ALL CONSTRUCTION GROUP

ADDENDUM NO.: 01
PROJECT NAME: North Park Village (NPV) Administration-Building C (Bid Package 1 – Campus Signage)
PROJECT NO.: 04038
DATE OF ISSUE: 6/8/2023

NOTICE OF CHANGES, MODIFICATIONS, OR CLARIFICATIONS TO CONTRACT DOCUMENTS

CAMPUS SIGNAGE PACKAGE ADDENDUM #1 2023.06.07

MAP,
BUILDING
AND
WAYFINDING
SIGNAGE
DETAILS

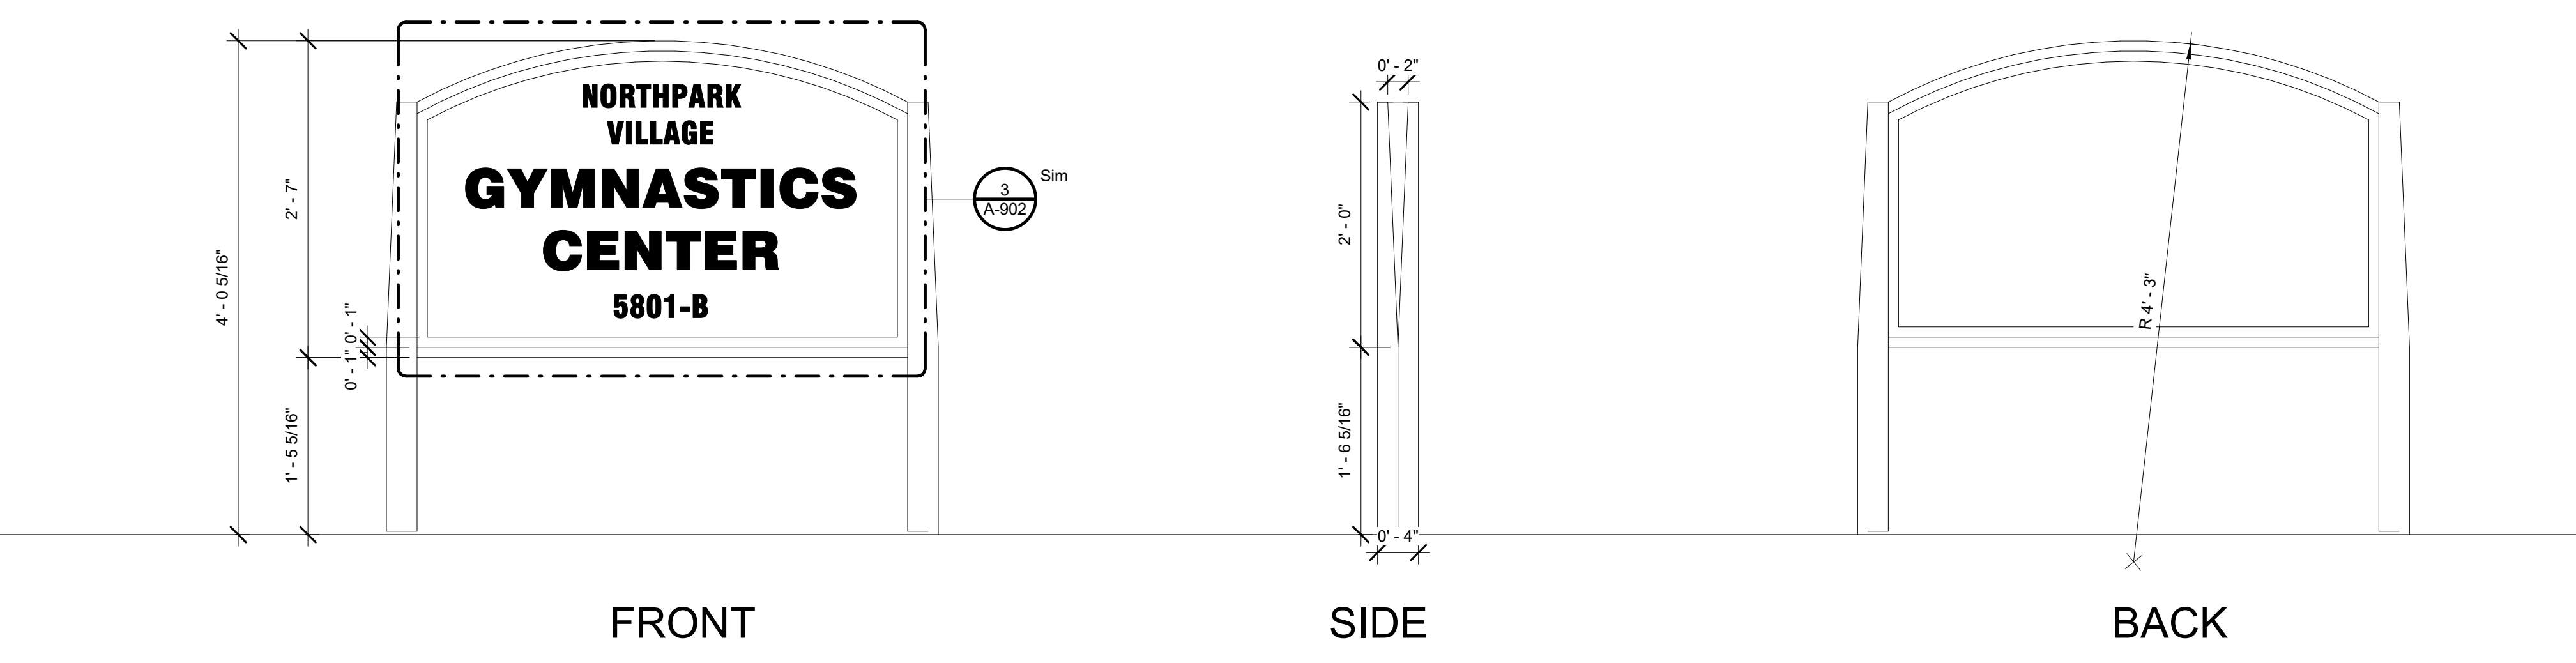
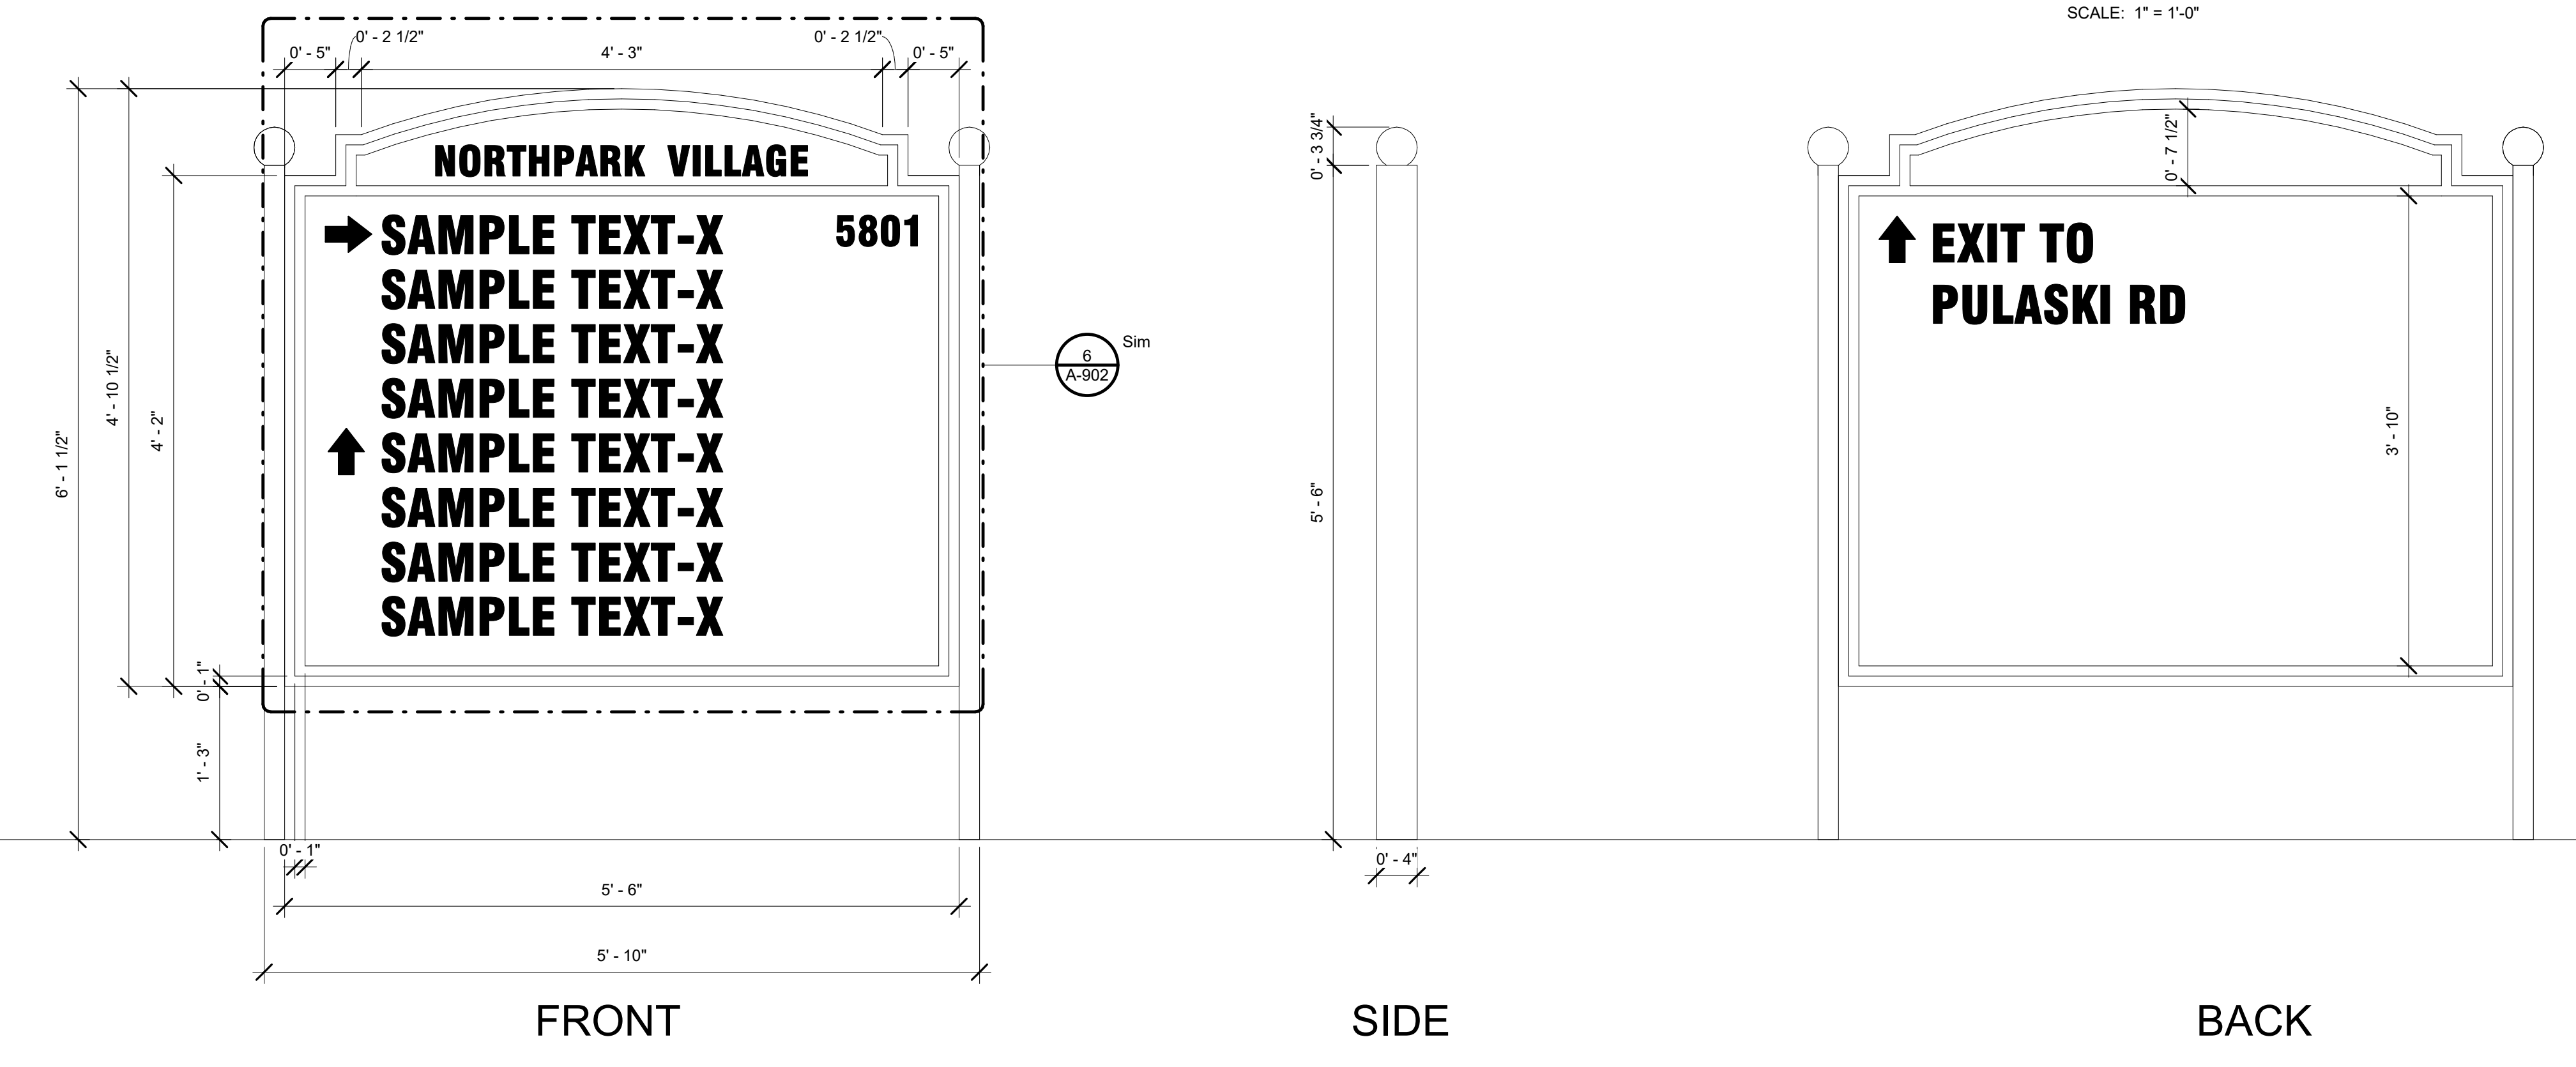
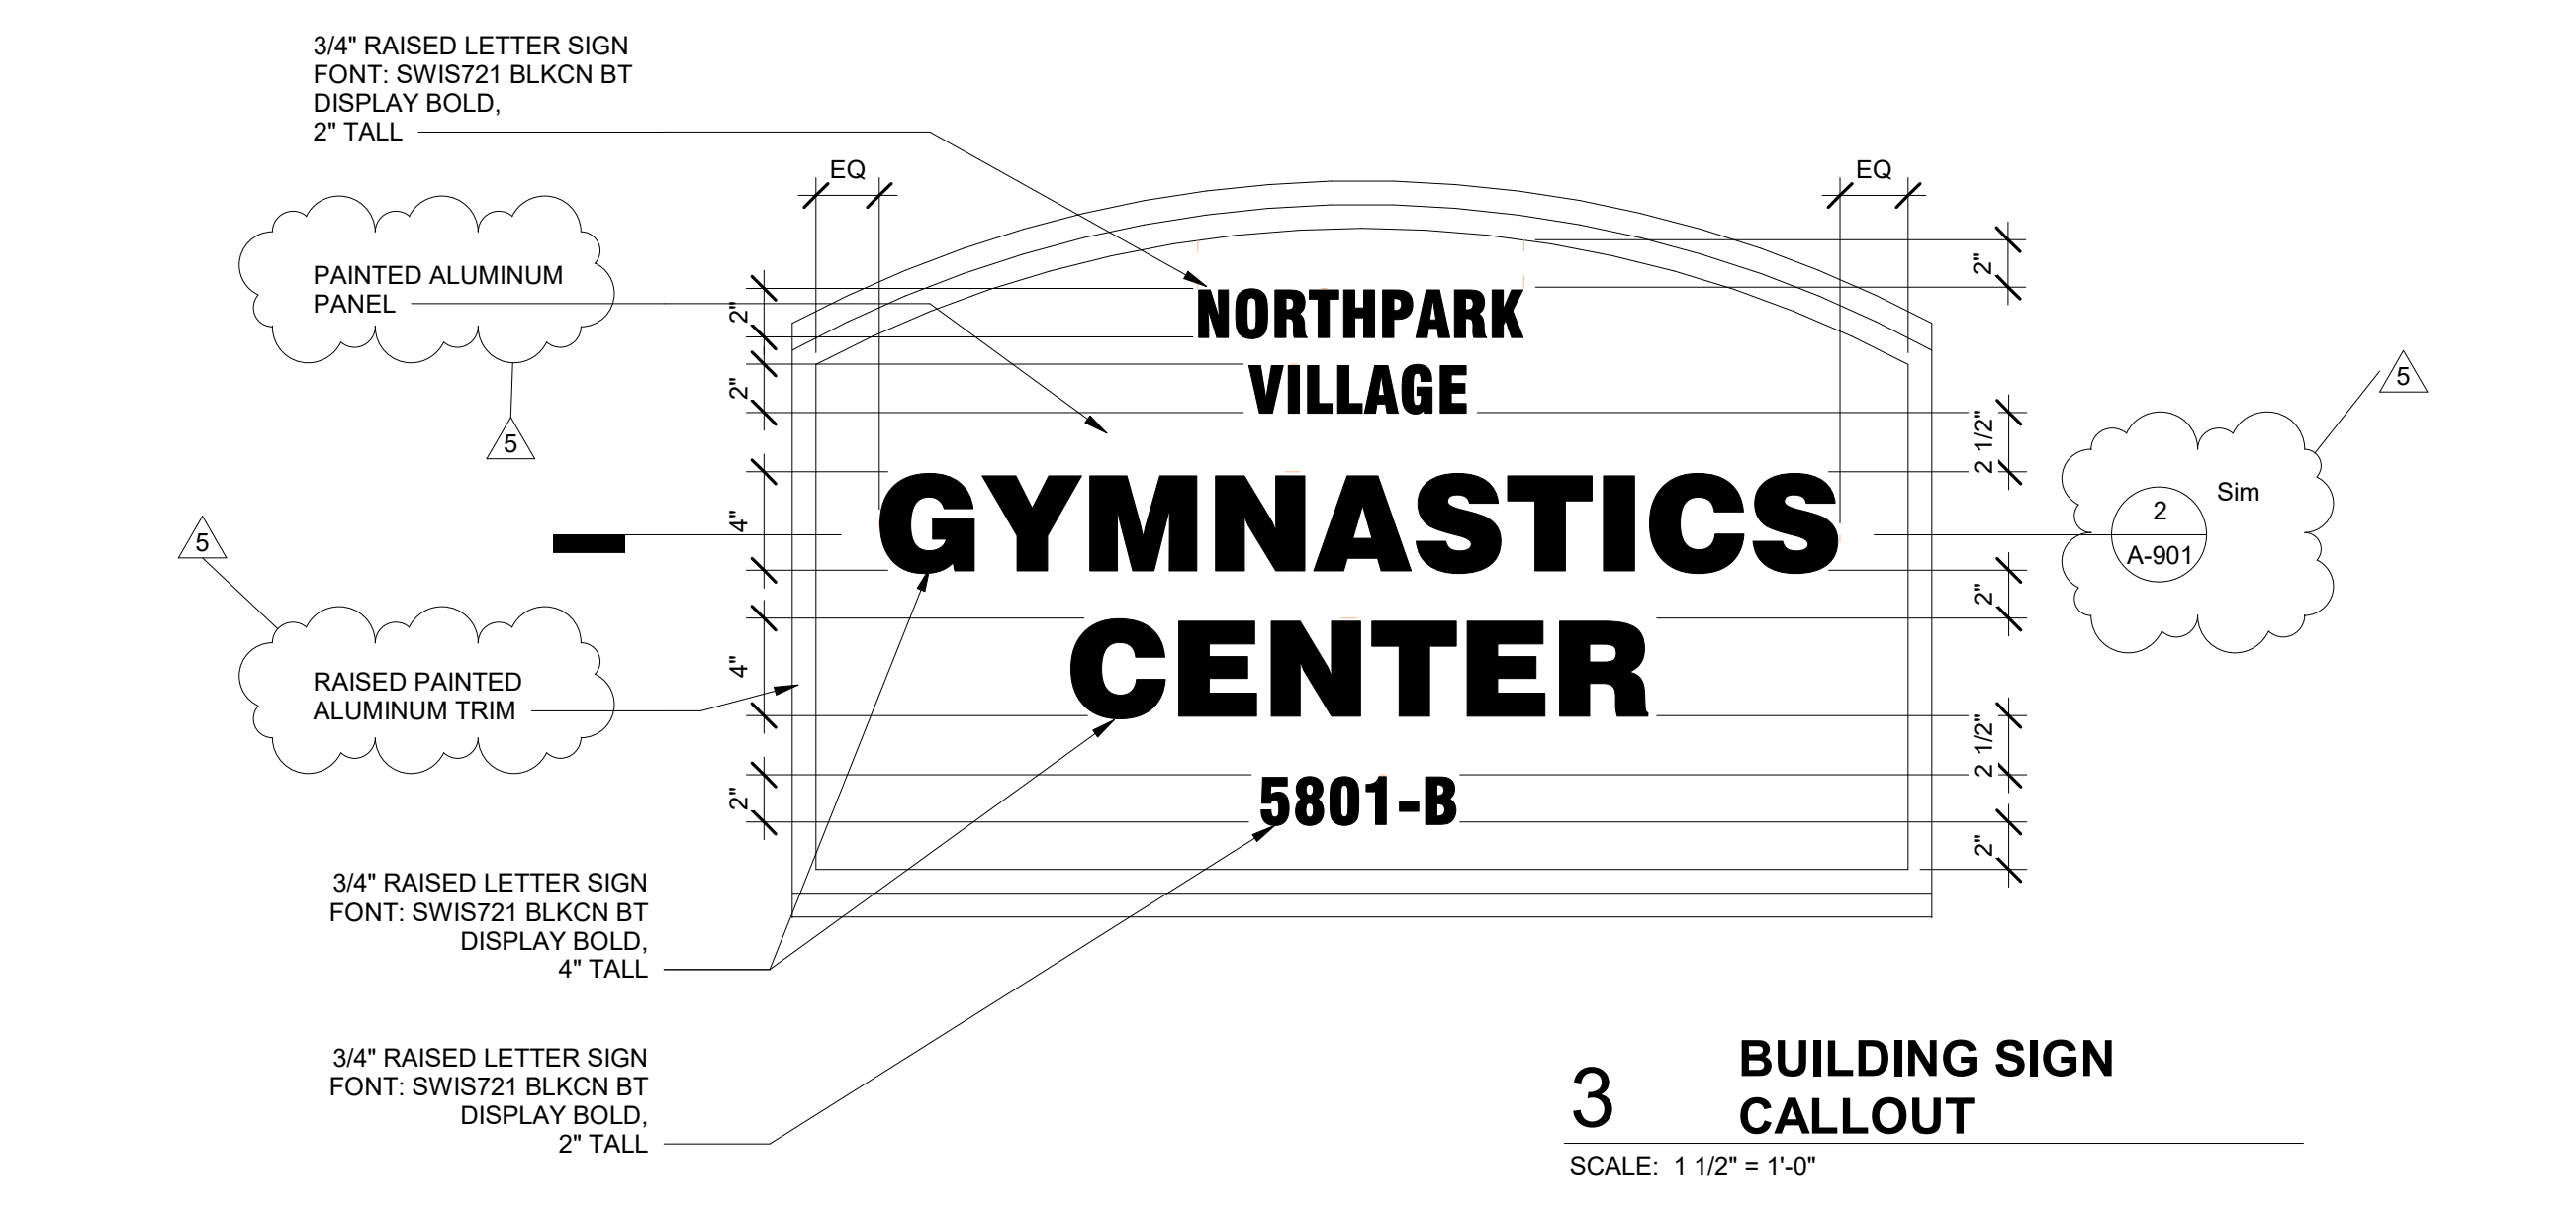
Change 4 **Revised** A-902, added notes regarding Aluminum Back Panel, Concrete Footing PSI, and Trim and addition of reference to cross section detail.

Question 2 We have gone through the drawings and are currently pricing everything. There is no information on the backer panel all the letters / maps are installed on. Do you have any more info or should

we make some assumptions? In addition, the letters are called out at $\frac{3}{4}$ " thick which is expensive, any interest in going to $\frac{1}{4}$ or $\frac{1}{2}$ to save money?

Answer: Back panels are to be painted aluminum. Letters are to be $\frac{3}{4}$ " thick as indicated on the Contract Documents. Please refer to revised Sheets A-901 and A-902.
